ORIGINATION FORM

Proposed Revisions to a Standard Plans Index

Index Number: 550-012
Sheet Number (s): 3 of 4
Index Title: BRIDGE FENCING (ENCLOSED)

BRIDGE FENCING (ENCLOSED)

INDEX	SHEET
550-012	3 of 4

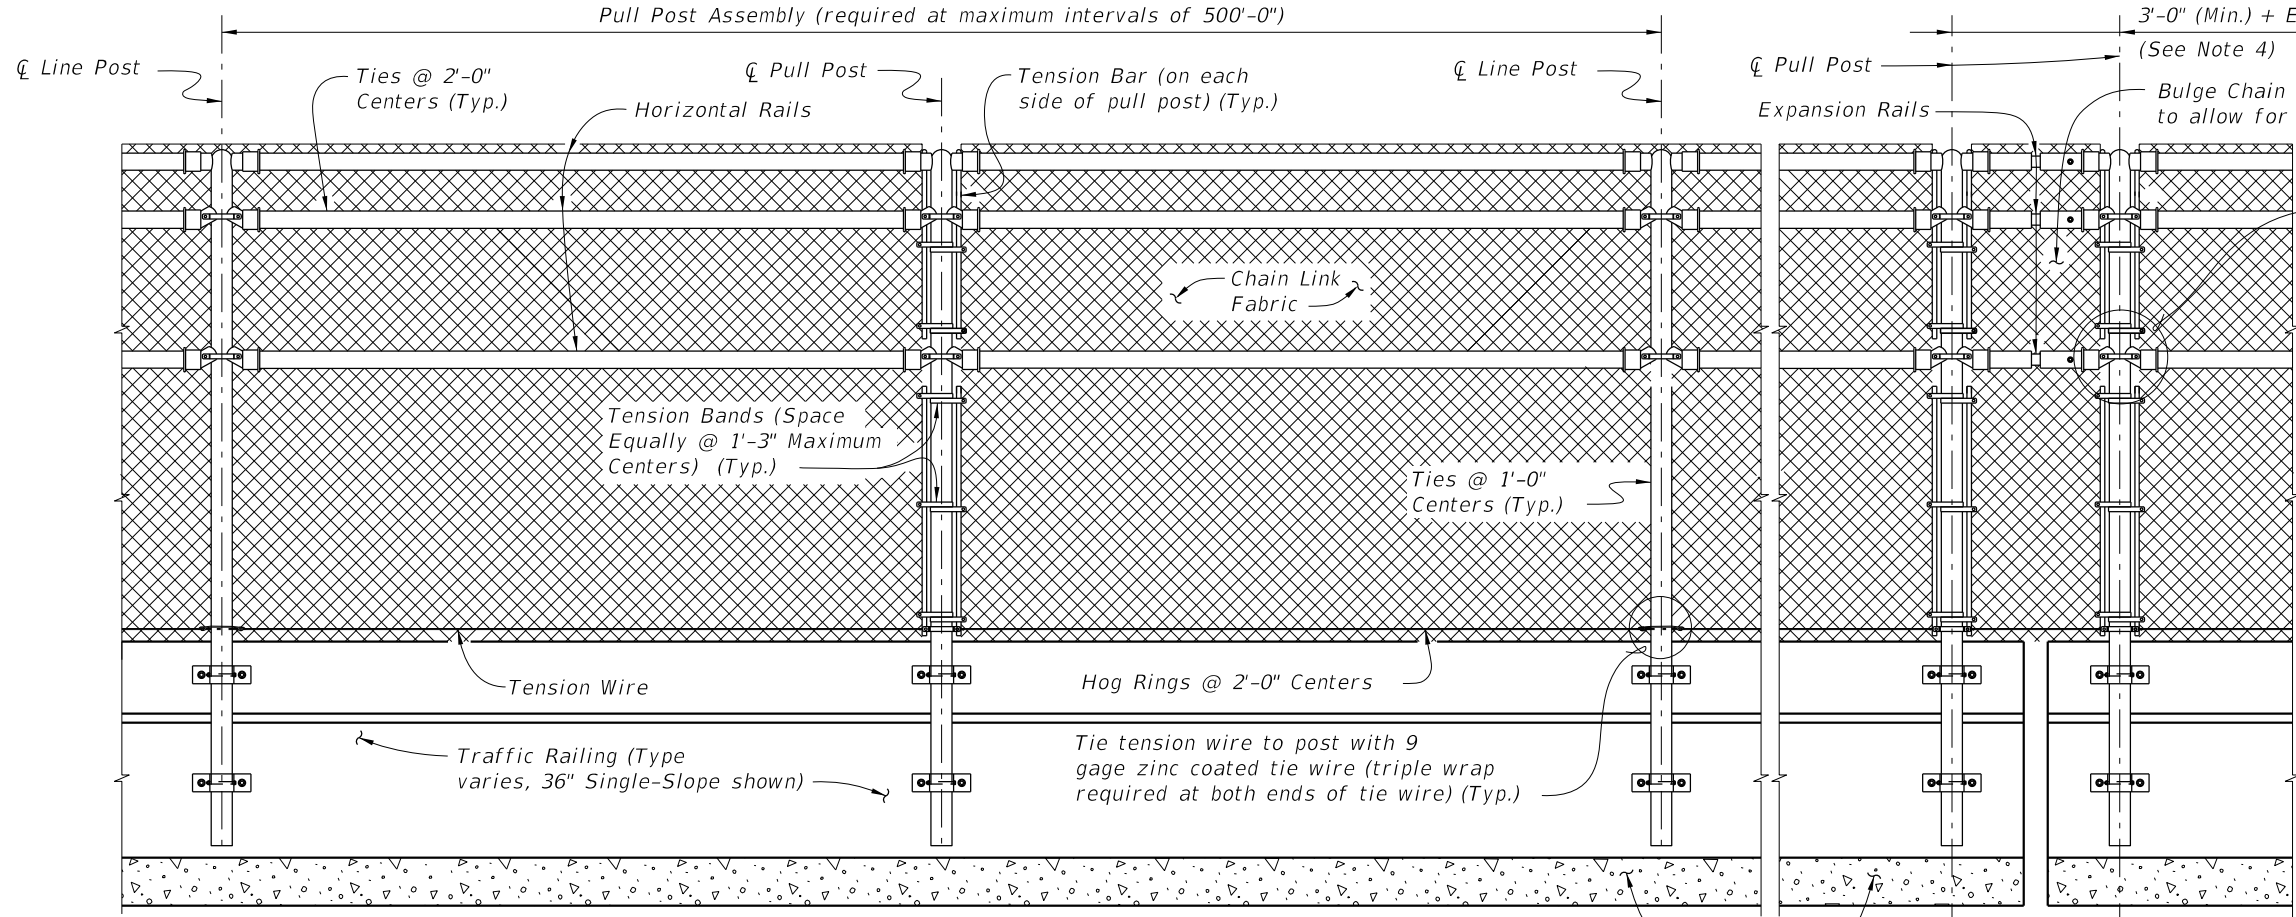
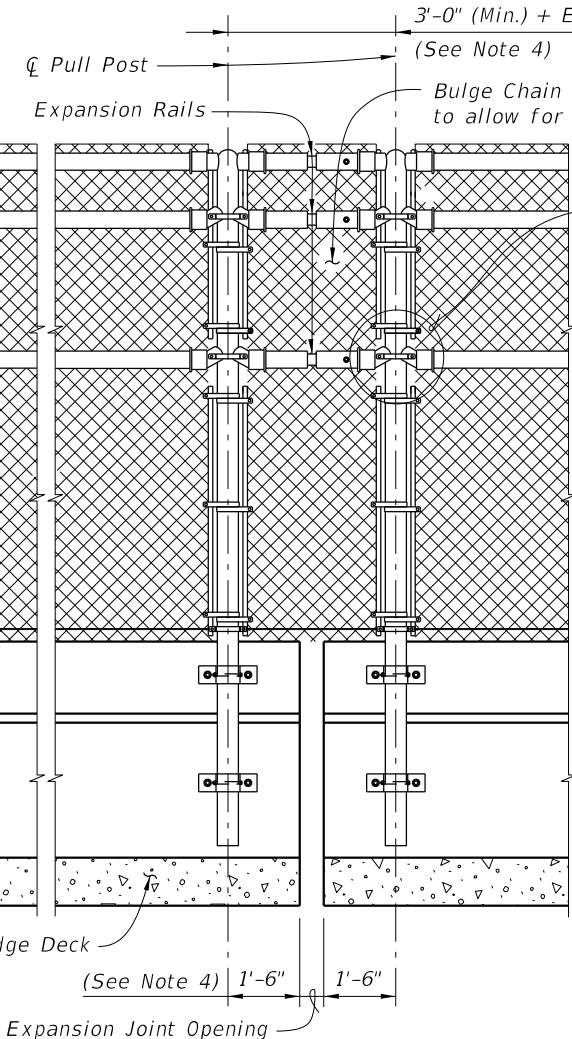
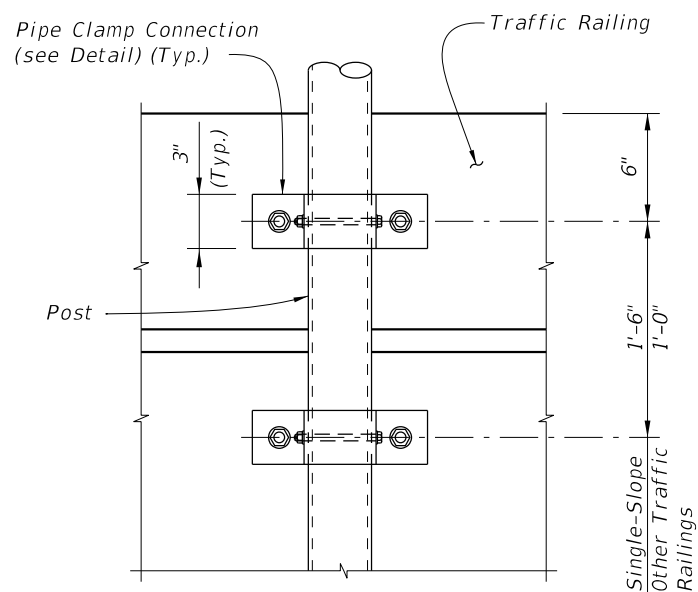
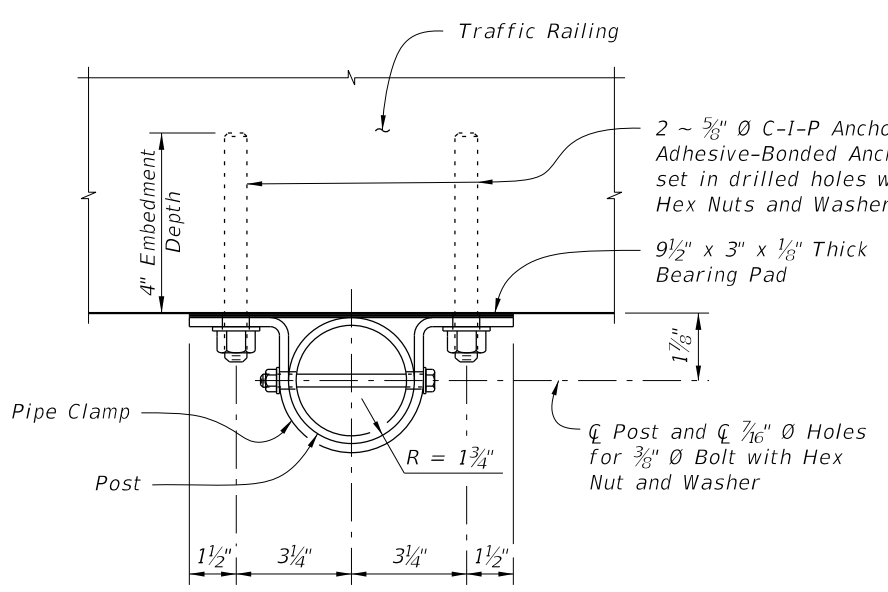
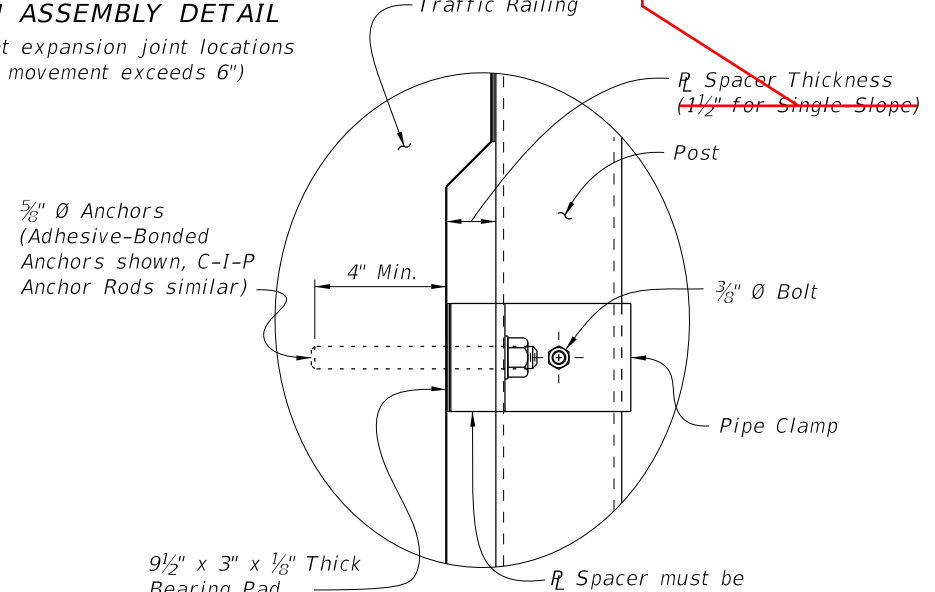
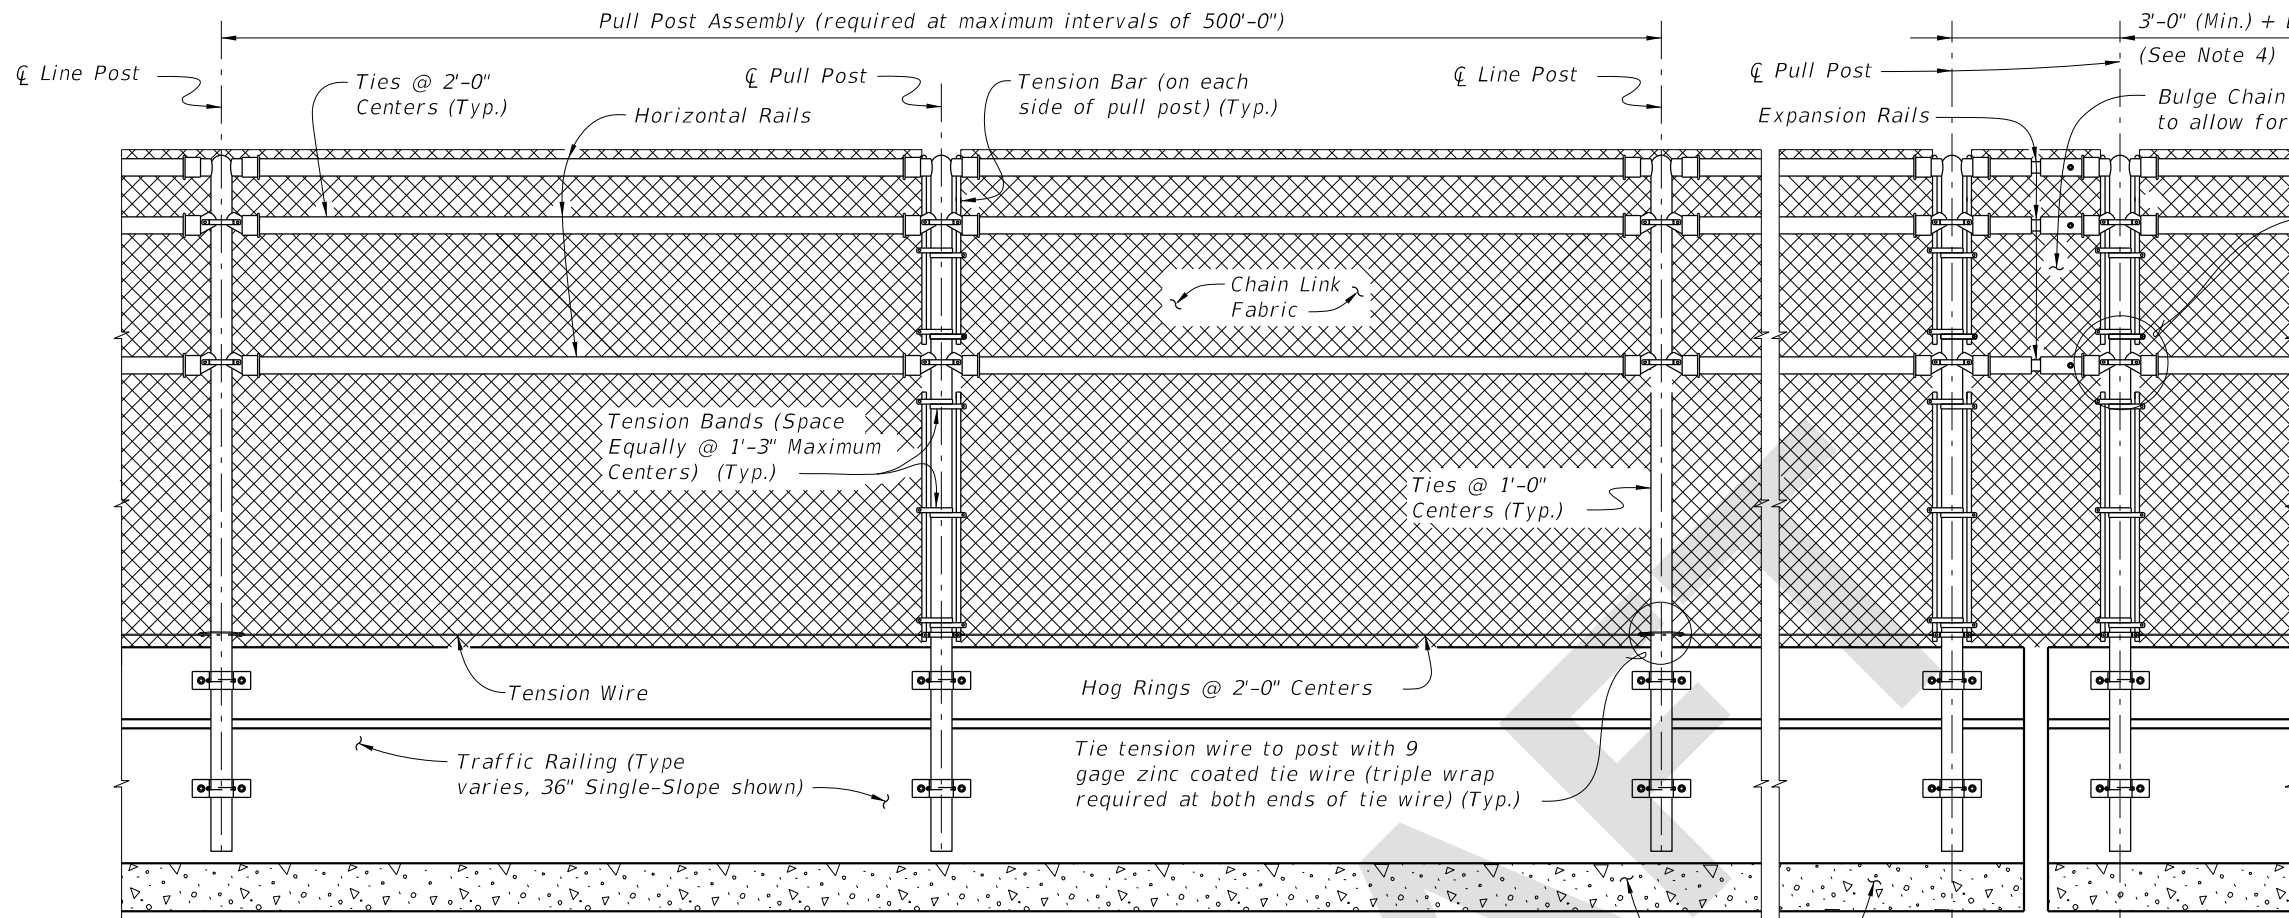
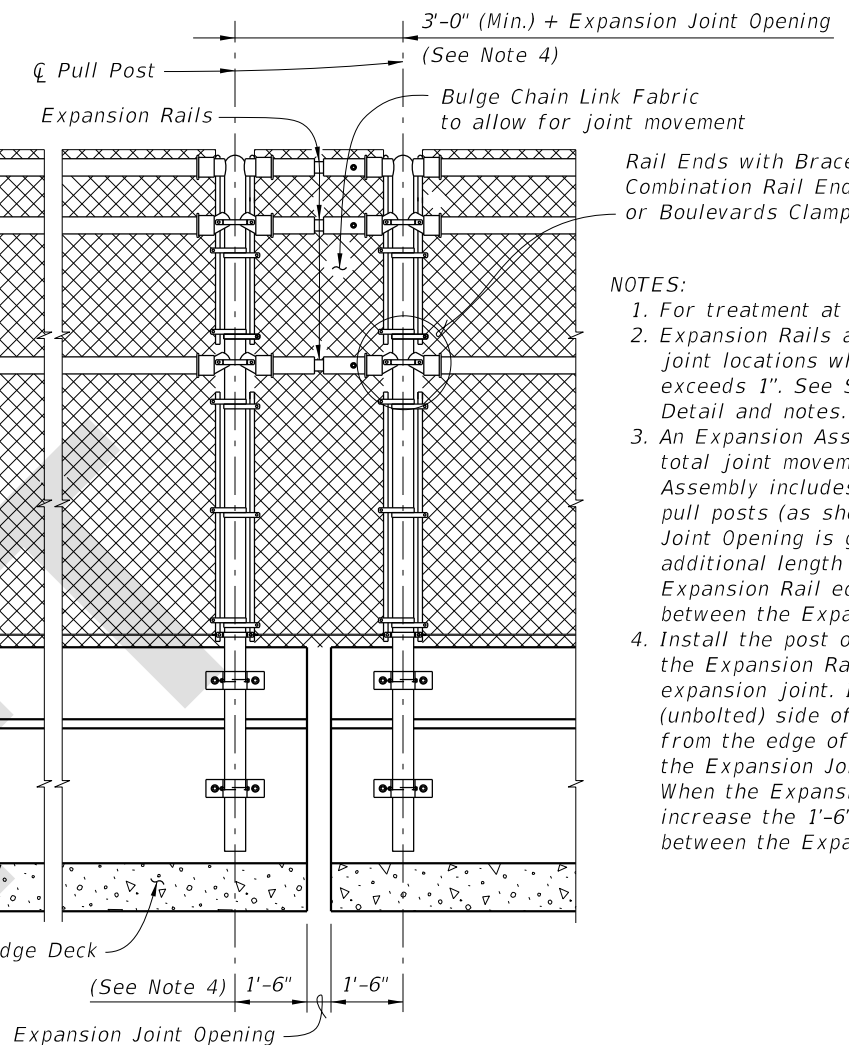
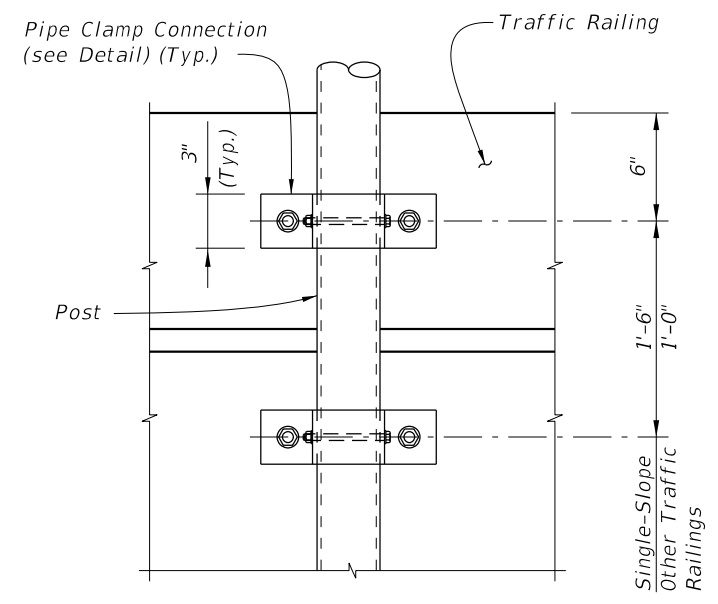
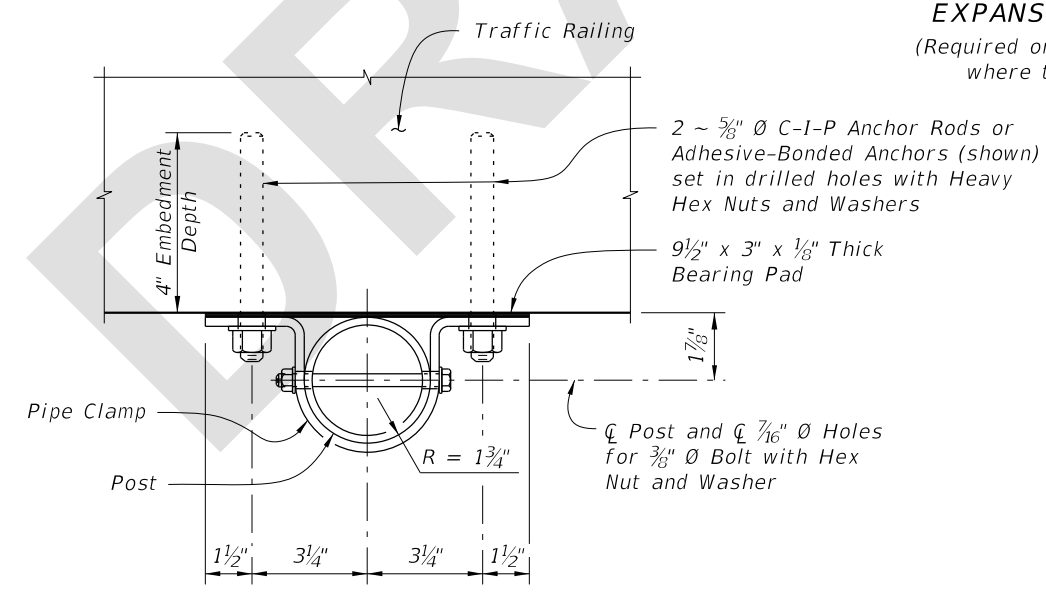
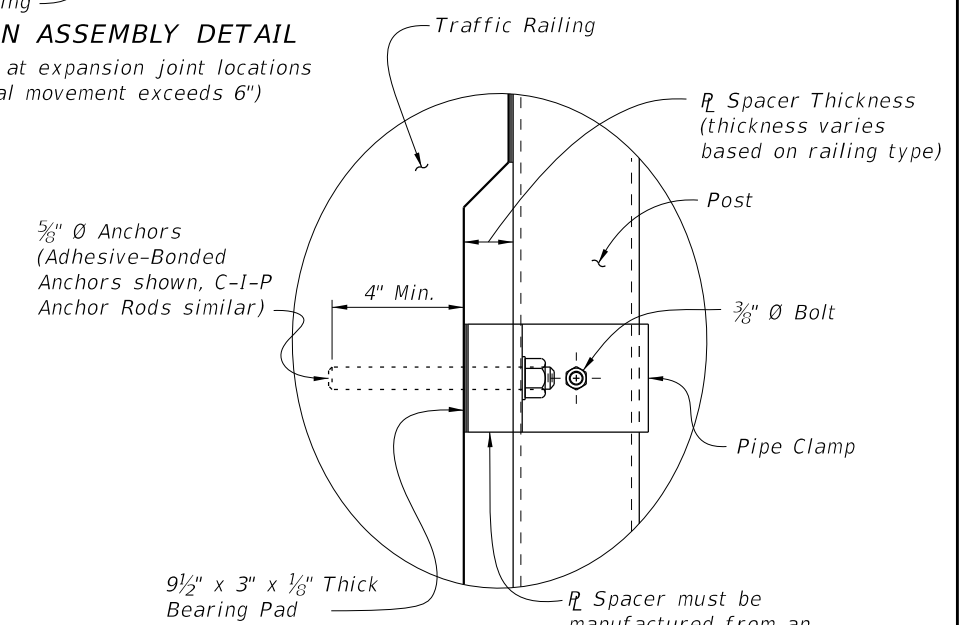
Sheet 3: Change the shim thickness at the base of the pole to indicate that it varies based on railing type.
